SERVICE NO. 1355 BULLETIN

Date: February 25, 2022

TEE BAR ASSEMBLY INSPECTION

Figure 2

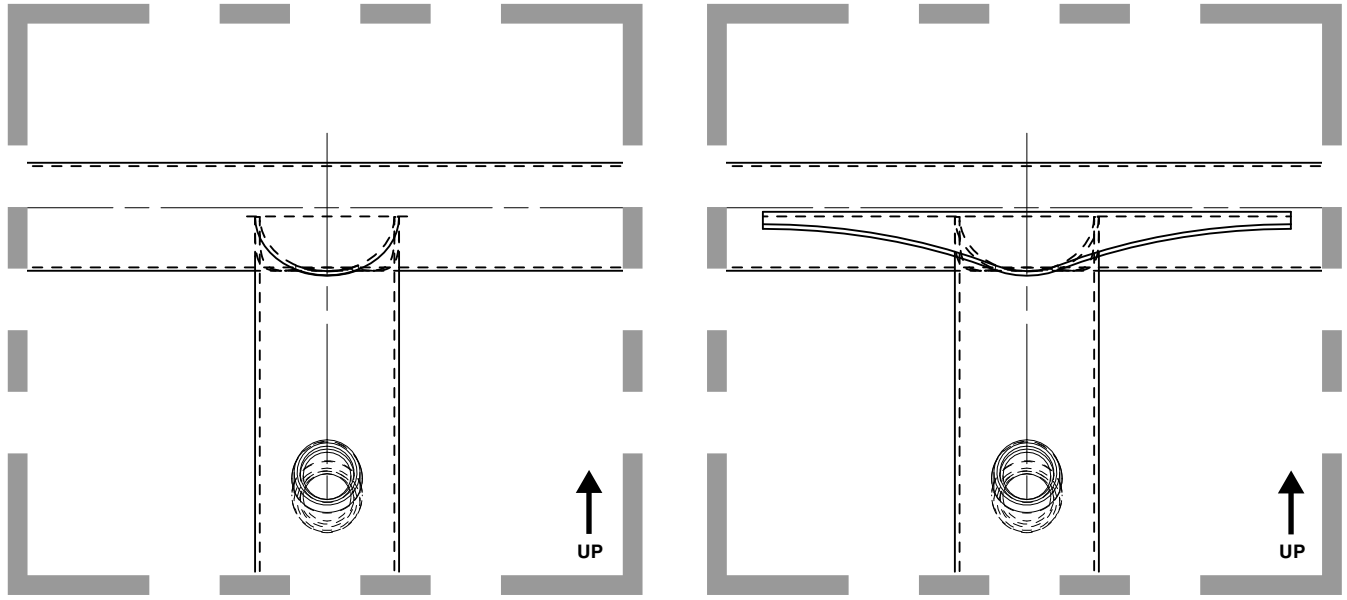
4. Assemble the control wheel tee bar assembly (refer to Figure 2): Install the sprockets, control wheel columns, and hardware, which were removed from the original weldment assembly in the previous step, onto the replacement tee bar weldment assembly.

Figure 1
Tee Bar Assembly – Weldment

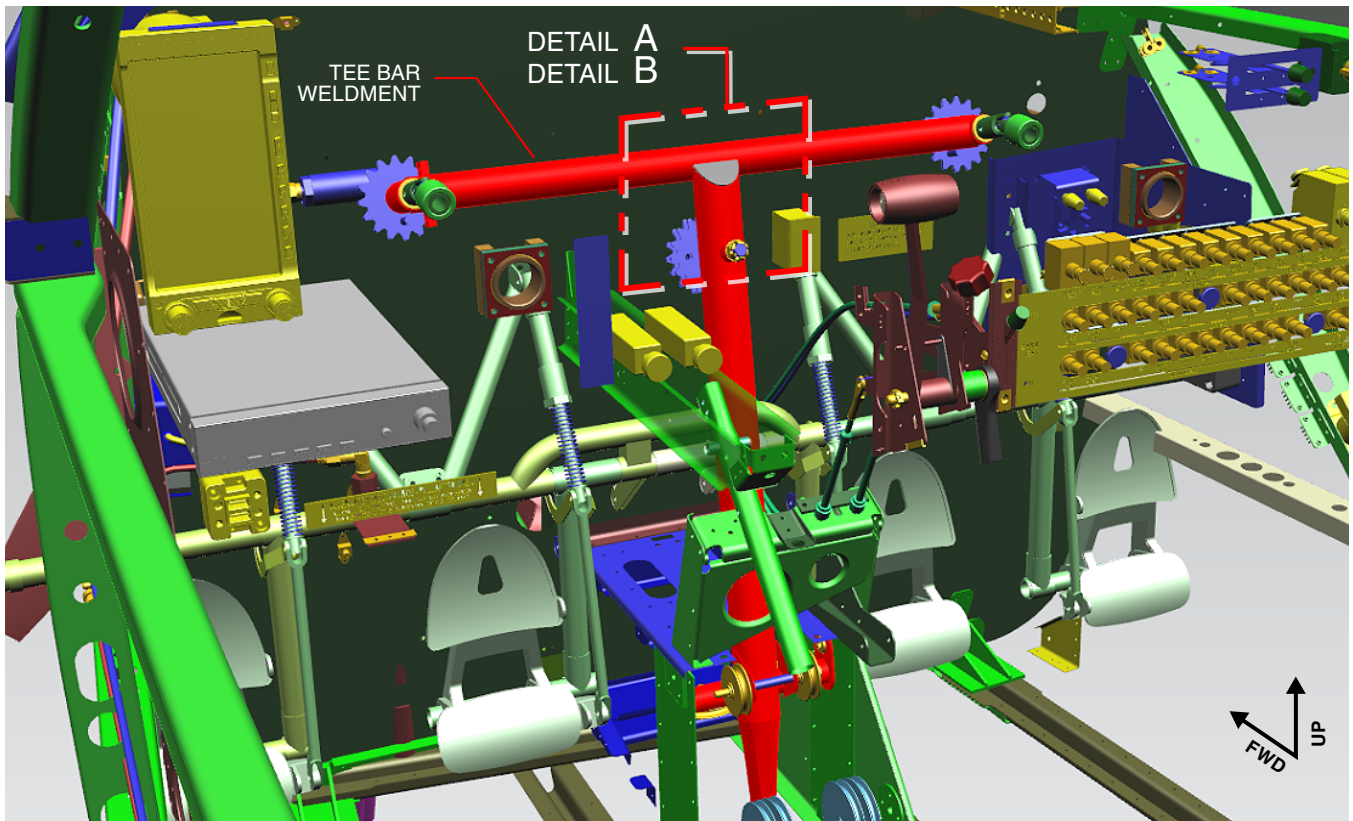
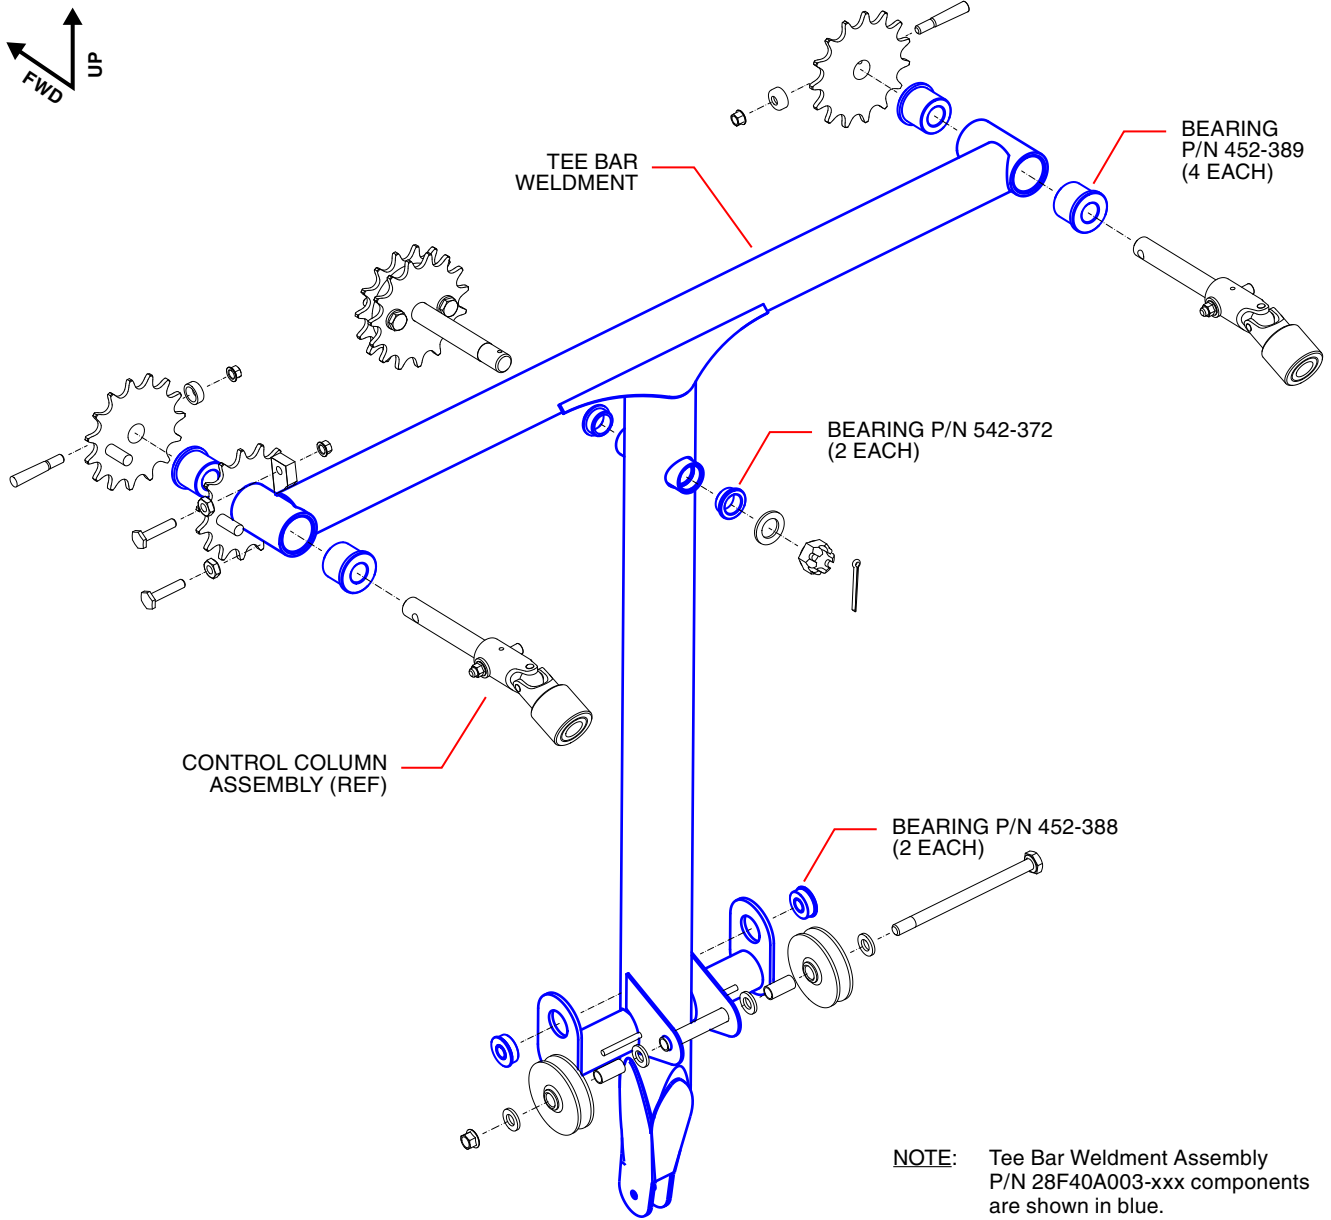
1. Gain visual access to the top center portion of the tee bar assembly, as shown in Figure 1. Identify the configuration of the tee bar weldment assembly.
 - If the local area conforms to Figure 1, Detail A, then recurring inspections are required. Proceed to Step 2.
 - If the local area conforms to Figure 1, Detail B, then the tee bar assembly has already been modified in accordance with Part II, or has been replaced with a tee bar assembly containing the required features (i.e., gusset). No recurring inspections are required. Proceed to Part II, Step 2.
2. Examine the area shown in Detail A for cracks, with special emphasis on welded joints.

- b. Perform a fluorescent dye penetrant inspection per FAA Advisory Circular AC 43.13-1B, Chapter 5, Section 5.
 - If any cracks are discovered, then the tee bar weldment must be replaced prior to next flight. Proceed to Part II.
 - If no cracks are discovered, apply primer and topcoat to bare metal, per the applicable Piper Airplane Maintenance Manual (AMM) or Service Manual (SM) and FAA Advisory Circular AC 43.13-1B, Chapter 6. Proceed to Step 3.
3. Perform a functional check on any systems that were disturbed during this inspection.
 4. Make a logbook entry documenting compliance with Part I this service bulletin.

NOTE: Modification of the tee bar assembly as described in Part II, or installation of a replacement tee bar assembly with the features shown in Figure 1, Detail B, will relieve the recurring inspection requirement in Part I.

Figure 3
Brass Shim P/N 62833-152 Installation Location

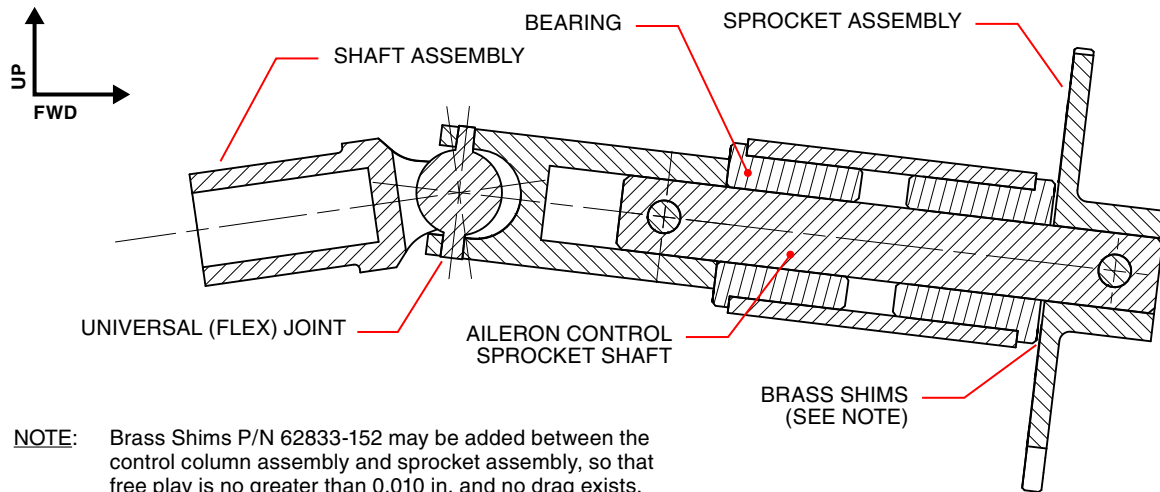
5. Reinstall the control column tee bar assembly and control wheel columns, in accordance with Section 27-10-00 of the applicable Piper AMM or Section V of the applicable SM. If necessary, so that there is no greater than 0.010 in. of free play (relative motion) and no drag exists between the control columns and sprocket assemblies, add Brass Shims, Piper P/N 62833-152, no more than two (2) per side, as shown in Figure 3.
